# PERMIT

SEWAGE DISPOSAL SYSTEM

MARYLAND STATE DEPARTMENT OF HEALTH DISTRICT 5th

SUBDIVISION Green Hill Manor - Sec. 5 ROAD 13522 Villa D'est Dr. LOT 3, Section 5

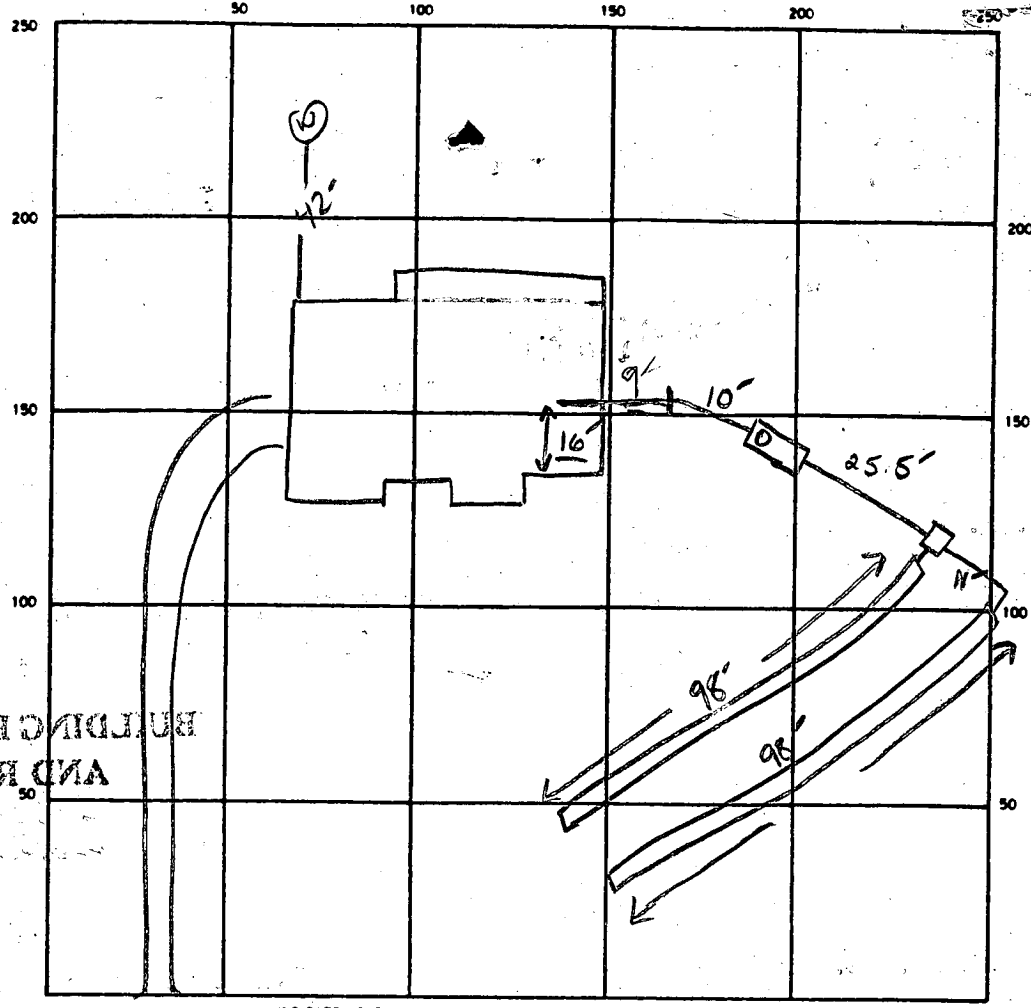
REMARKS 5-9-89 - OK TO STONE BOTH TRENCHES - ADD HOUSE CONNECTION. SCL

5-9-89 - OK TO COVER ALL WORK. CALL WHEN HOUSE CONNECTION MADE FOR FINAL SCL

5-12-89 9' NOT CONNECTED YET. - Partial only; CBS

5/14/89 HOUSE CONN. OK - OK TO COVER MR

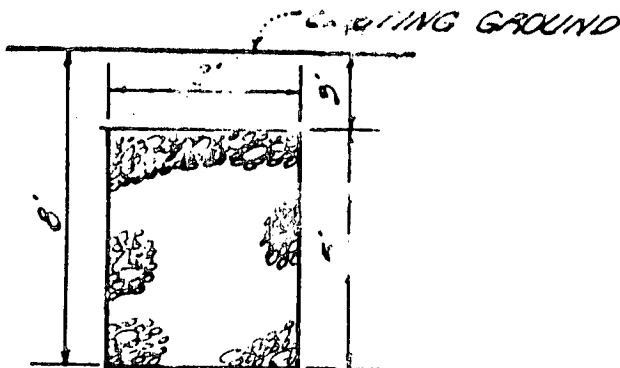
✓  
 LOT #2  
 INV. ELEV. (OUT OF) HOUSE 477.09 ✓ (-BSMT)  
 INV. ELEV. (INTO) SEPTIC TANK 476.84 ✓  
 EXIST. ELEV. @ SEPTIC TANK 472.20 ✓  
 INV. ELEV. (OUT OF) SEPTIC TANK 476.51 ✓  
 INV. ELEV. (INTO) DISTRIBUTION BOX 476.23 ✓  
 EXIST. ELEV. @ DISTRIBUTION BOX 472.20 ✓  
 INV. ELEV. (OUT OF) DISTRIBUTION BOX ~~475.50~~  
 EXIST. ELEV. @ TRENCH 472.30 476.2 ✓  
 SHOULD BE 480.0  
 PLACED AT 21

LOCATION OF HOUSE  
 "GREEN HILL MANOR"  
 LOT 3 SECTION 5  
 YILLA D'EST DRIVE  
 HOWARD COUNTY, MARYLAND

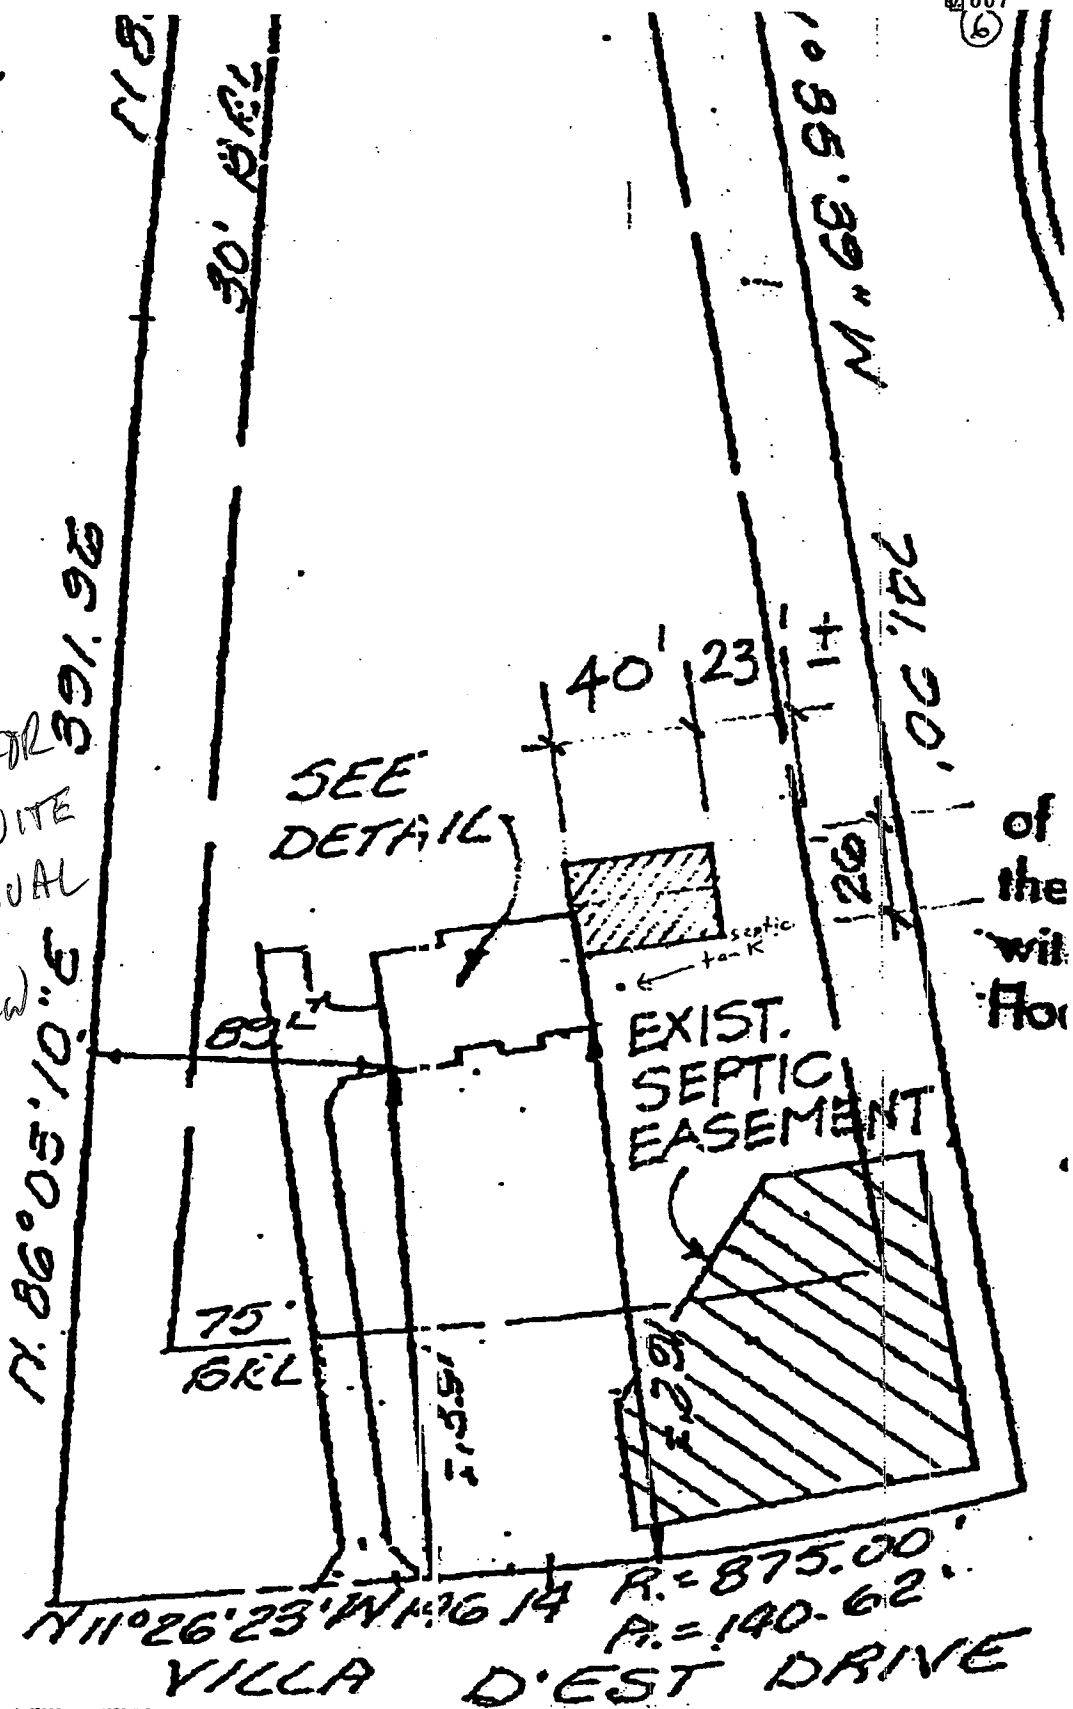
3/31/04  
 ADD'N OR FDR  
 HBR INLAW SUITE  
 SUBJECT TO VISUAL  
 INSPECTION +  
 PERMIT FOR NEW  
 CONNECTION  
 1:60

T/C W/SENDER RE: 1 BR INLAW SUITE ADD'N  
TO EX. 4BR HOUSE  
PER REVISED DESIGN SPECS,  
EX. SYS. ADEQUATE AS INSTALLED,  
SUBJECT TO SITE INSP TO VERIFY  
NO VISIBLE DISCH. + REPAIR PERMIT  
TO CONNECT ADD'N TO EX. S. TANK,  
HE WILL HAVE ADD'N  
STAKED OUT & NOTIFY
